**Subject: Transmittal of the Responses to October 1, 2013 ACRS Comments on
GSI-191/LTCC**

**Responses to October 1, 2013 ACRS Comments on
GSI-191/LTCC**

**US-APWR Design Control Document
Mitsubishi Heavy Industries, Ltd.**

CHAPTER: 6
CHAPTER TITLE: ENGINEERED SAFETY FEATURES
DATE OF MEETING: 10/01/2013

Figure 1-1 Isometric Drawing of the Refueling Cavity Drain Line

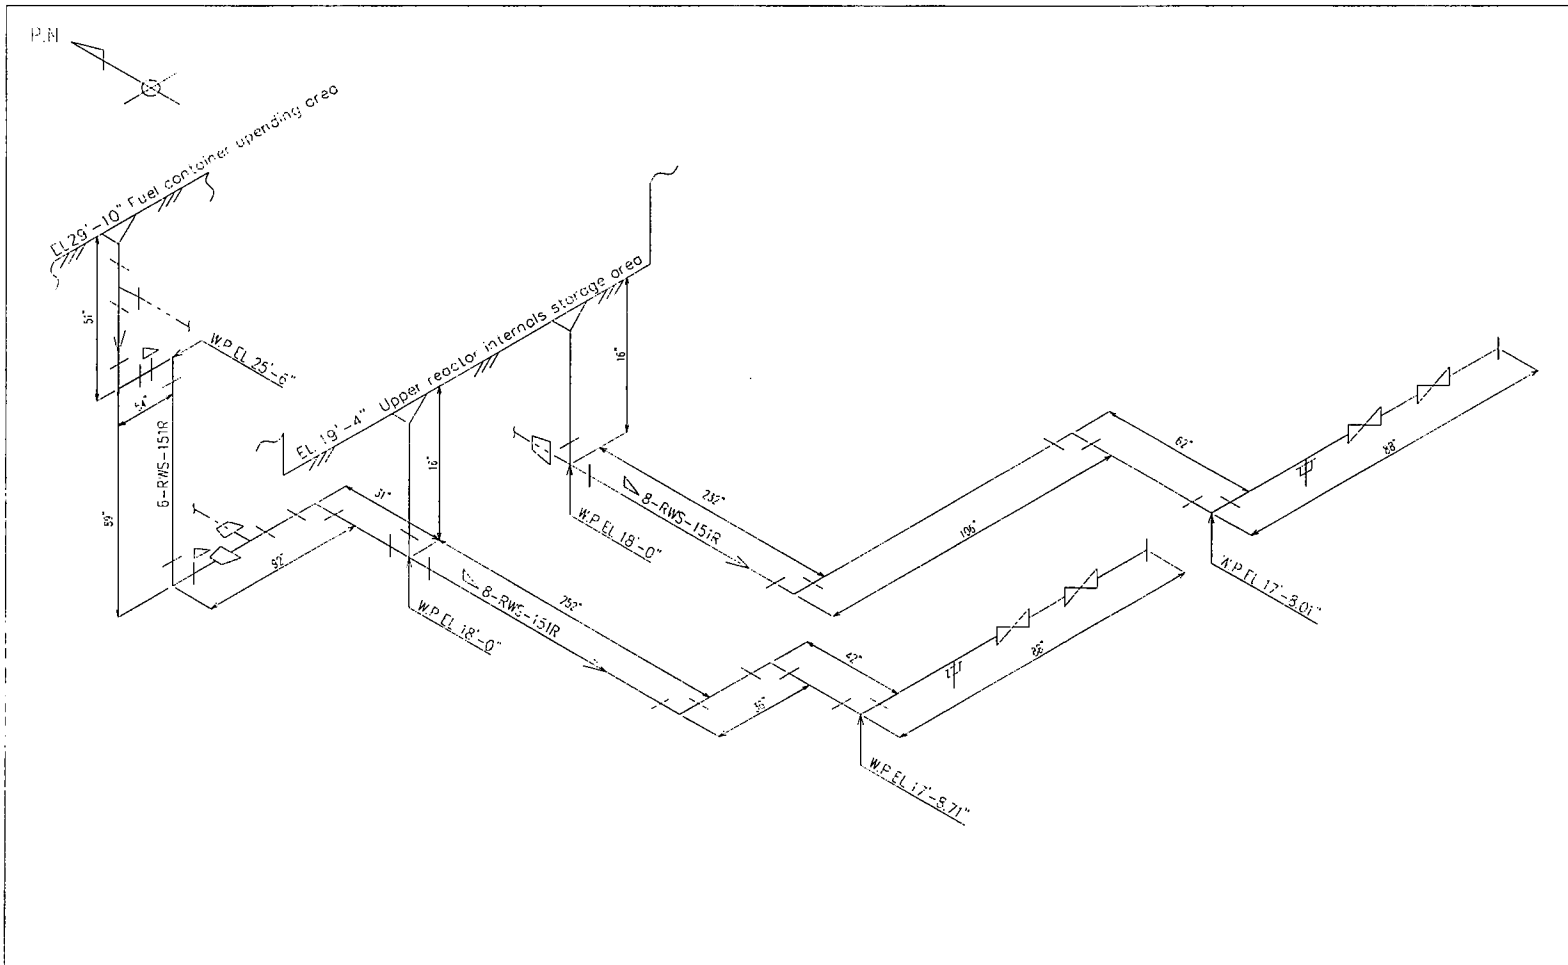
Check the design specification for the refueling cavity drain line and provide an explanation for why the line is not expected to be plugged up / clogged by debris.

MUAP-08001 "US-APWR Sump Strainer Performance" Section 3.7.1 identifies two possible choke points in the containment spray/blowdown return pathway for the US-APWR – the refueling cavity drain lines and the RWSP overflow lines. In both cases, the conclusion is that the lines will not be clogged by debris. The rationale for this conclusion with respect to the refueling cavity drain line is further explained below.

1. Debris Source for the Refueling Cavity Drain Line
For the US-APWR, the majority of debris will be generated in the SG compartments. There is no direct flow path between the SG compartments and the opening of the refueling cavity drain lines (two 8" lines), which are located at the bottom of the refueling cavity. Therefore, latent and miscellaneous debris are the primary type of debris that may be expected to reach the refueling cavity. However, grating with an opening size of 1" by 4" is arranged above the 8" diameter refueling cavity drain lines as shown in Figure 3-9 of MUAP-08001. This grating ensures that only "fine" and "small" latent fiber debris and particulate latent debris, which are smaller than 8" diameter, could reach the refueling cavity drain lines.

2. Refueling Cavity Drain Line Configuration
The refueling cavity drain lines have three upper sections one of which is located at the fuel container upending area on EL. 29'-10" and the other two are located at the upper reactor internals storage area on EL 19'-14". The line from the fuel container upending area and one of the lines from the upper reactor internals storage area merge to one line. The other line from the upper reactor internals storage area does not merge with the others. In other words, both drain lines are independently arranged with the lower ends draining to the Header Compartment area. (See Figure 1-1) The total length of the drain lines are approximately 60 ft and 42 ft, respectively, and both lines are arranged with approximately 1/100 slope.

The estimated minimum flow velocity is 0.85 ft/sec. With reference to NEI 04-07, the maximum fiber settling velocity for NUKON™ is 0.41 ft/sec for 6 in size, and its incipient tumbling velocity is 0.16 ft/sec maximum for a 1/4" by 1/4" clump. The 0.85 ft/sec estimated minimum flow velocity of the drain line is much higher than that of the NUKON™ fiber settling velocity and incipient tumbling velocity. Therefore, MHI concludes that there is a very small chance for the drain line to be clogged by debris in the line.

- As discussed in the item 1 above, the debris size which could reach those drain lines is expected to be smaller than the corresponding drain line inner diameter.
- As discussed in the item 2 above, the drain lines are relatively short and are sloped.
- As discussed in the item 3 above, the estimated minimum flow velocity of the drain line is much higher than the NUKON™ fiber settling velocity and incipient tumbling velocity.

Figure 11-1 Plant Elevation Associated with Water Level for Minimum Water Level Calculation

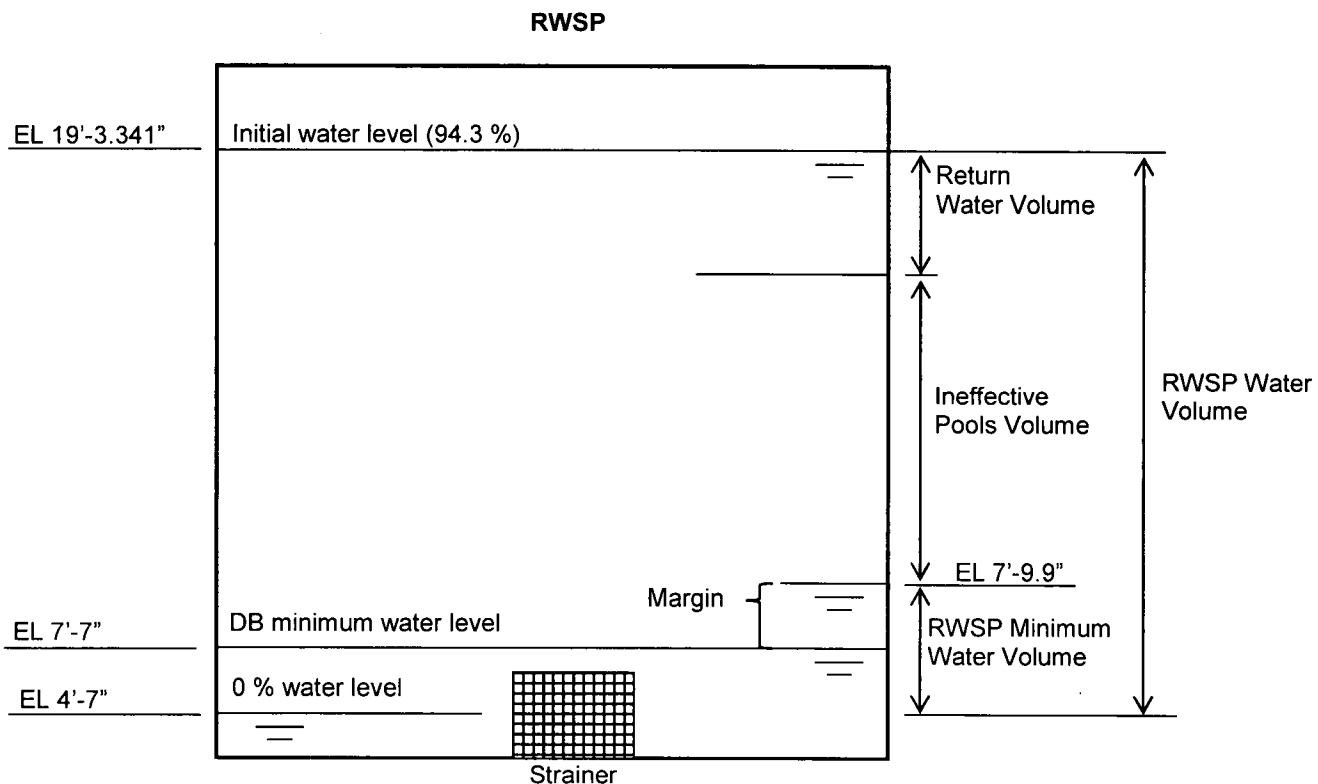
Annotate Slide 58 to show the plant elevation associated with each RWSP level depicted on this figure.

The requested evaluation information has been added to Figure 11-1. It is noted that the volumetric relation is provided in Figure 3-11 of MUAP-08001 "US-APWR Sump Strainer Performance".

Figure 12-1 NPSH Available vs. Time

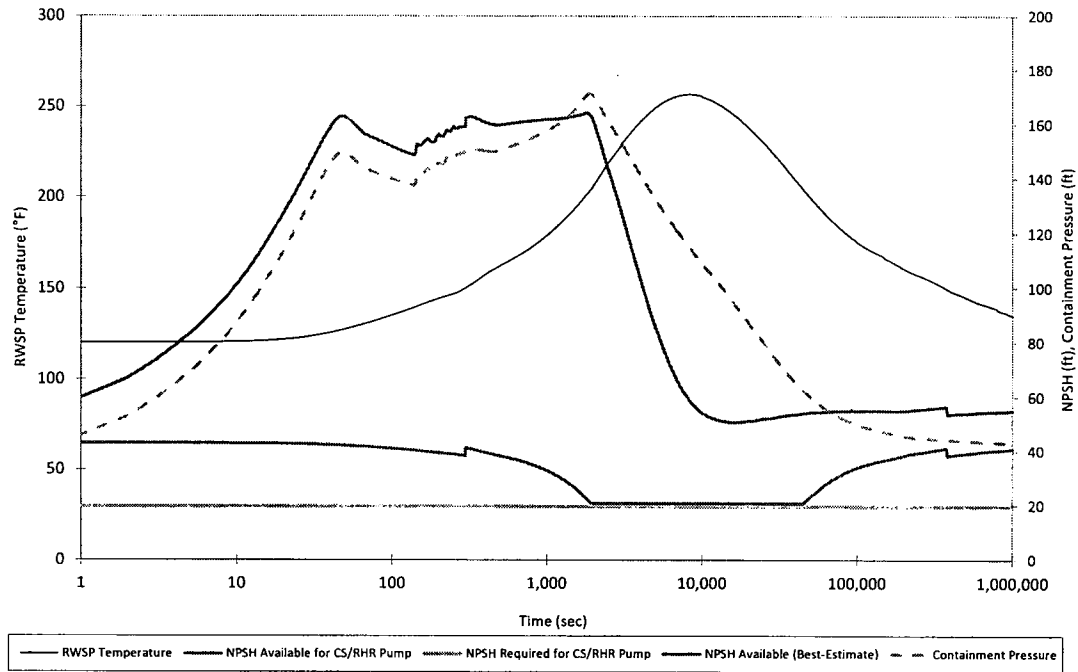
Supply an expansion of the plot given in Slide 61 over the first however long that time period is, 20 to 30 hours, to show in detail how the NPSH available versus NPSH required varies in a realistic analysis. Provide an expanded view of the plot on Slide 61 for the first 12 hours of the transient for both the realistic analysis and the limiting case.

Figure 12-1 show the expanded view of the plot of NPSH available vs. time for the first time range. In addition, plots of best-estimate NPSH available and the containment pressure are added to this figure.

The best-estimate NPSH available is calculated without assuming that "the containment pressure equals to the saturation pressure of the RWSP water temperature". Therefore, this is the case that the pressure at the water surface is the containment pressure.

NPSH available (design-basis) decreases at approx. 30 minutes (1,800 seconds) due to the increase of the RWSP fluid temperature. When the RWSP water temperature exceeds approximately 212°F, the NPSH available for the design-basis is assumed constant because of the assumption that the containment pressure equals to the saturation pressure of the RWSP water temperature. After the RWSP temperature drops below approximately 212°F, NPSH available increases due to the RWSP temperature decrease. In this figure, there is a little margin between NPSH available (design-basis) and NPSH required during the RWSP temperature above 212°F, but there is more than 1 feet margin as shown in Figure 3-17 and Table 3-11 of MUAP-08001.

On the other hand, the increase in NPSH available (best-estimate) at 30 minutes corresponds to the increase in the containment pressure. Since the NPSH available (best-estimate) is much larger than the NPSH available (design-basis) during the period of time when the RWSP temperature is over 212 °F, it is concluded that MHI's current evaluation of NPSH available (design-basis) has sufficient margin and is sufficiently conservative.
